Federal Register

[Docket No. FAA-2011-1231; Directorate Identifier 2011-NM-088-AD; Amendment 39-17418; AD 2013-08-01]

Airworthiness Directives; The Boeing Company Airplanes

ACTION: Final rule.

Figure 1, Fastener Removal of the Retainer Support on the Left Thrust Reverser Half

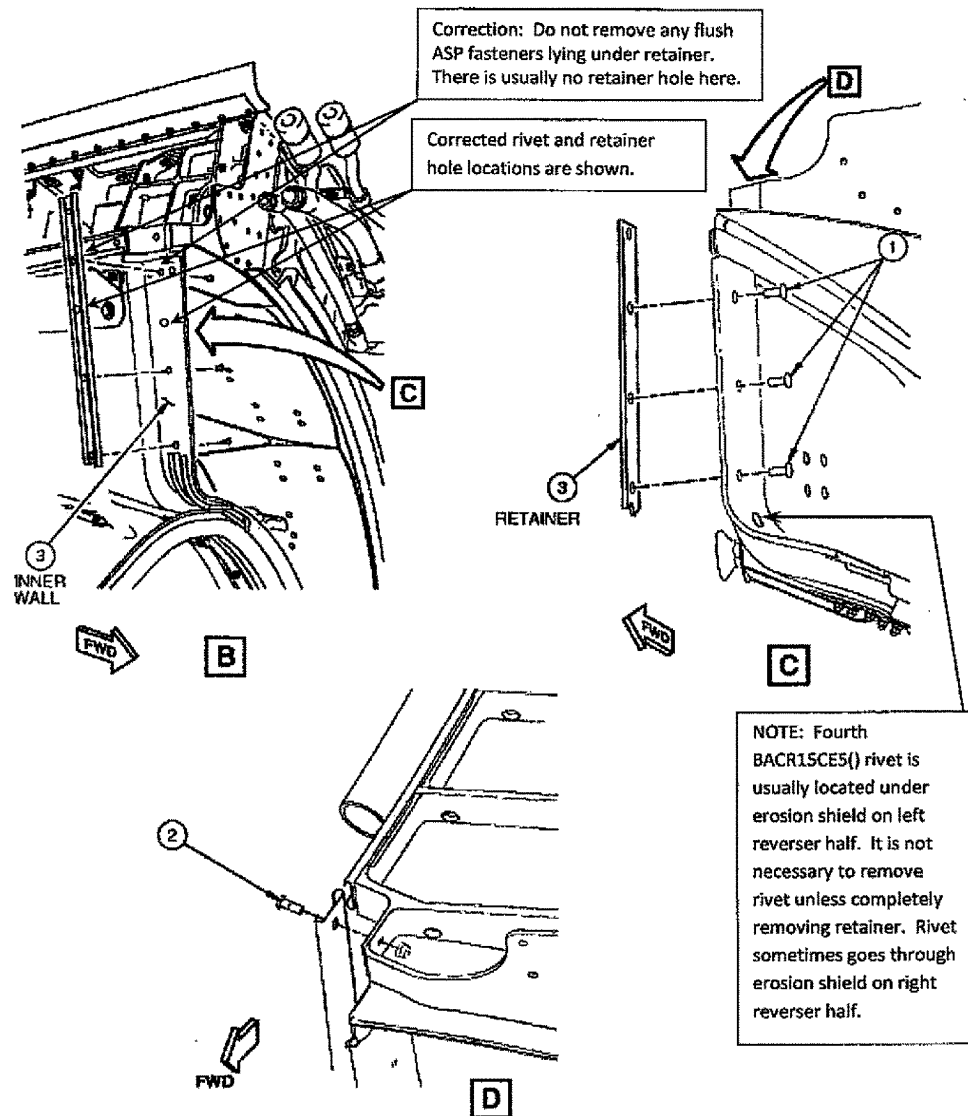
- Figure 10, Sheet 3 of 3: Note row (a) of the table shown in Figure 10, incorrectly refers the reader to "(a)" instead of Note row (b).
- Figures 6, 7, 15, and 16, all Sheet 2 of 3, all View B: These illustrations show the top fastener to be removed in the center of three fasteners in order to remove the retainer. However, these three fasteners are adjustable sustained preload (ASP) fasteners that do not require removal for this action. View B also incorrectly shows the location of the top rivet hole, which is actually below the row of ASP fasteners. These errors in those figures affect the actions specified in paragraph (g)(2) of this AD. The other instructions in the figures are correct.

(2) Figures 1 and 3 of this AD, titled “Fastener Removal of the Retainer Support on the Left (Right) Thrust Reverser Half,” have View B showing the top fastener in the center of three adjustable sustained preload (ASP) fasteners. That top fastener does not require removal in order to remove the retainer. The figures in this AD point to the correct information for those fasteners.

Figure 2, Installation of the New Bracket behind the Retainer Support on the Left Thrust Reverser Half

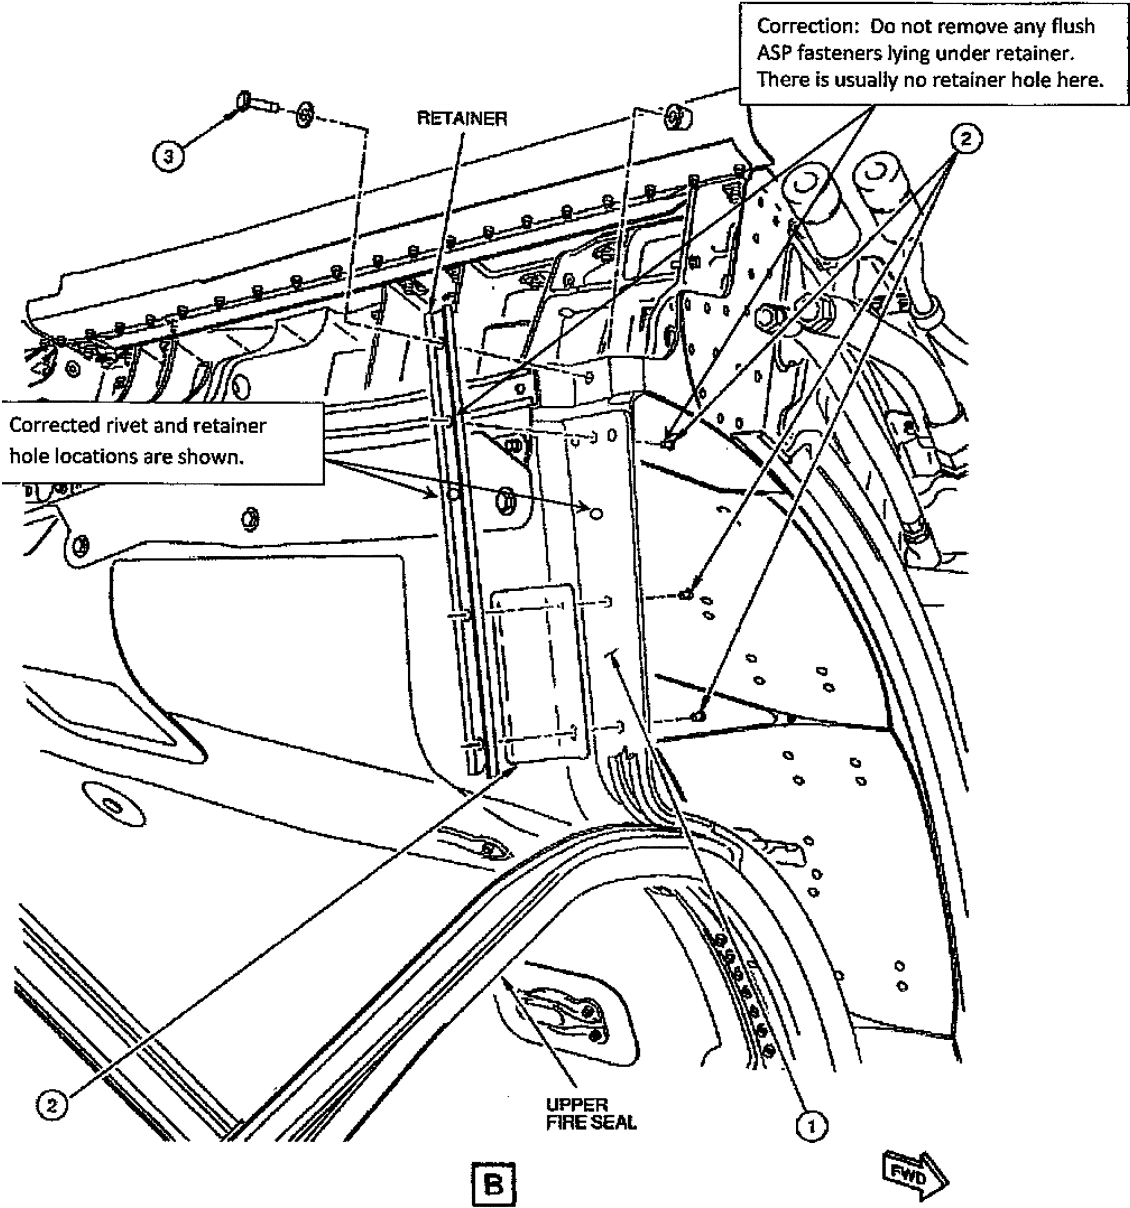
(3) Figures 2 and 4 of this AD, titled “Installation of the New Bracket behind the Retainer Support on the Left (Right) Thrust Reverser Half,” have View B showing the top rivet hole. That rivet hole is actually below the row of three ASP fasteners. The figures in this AD point to the correct information for those rivet holes.
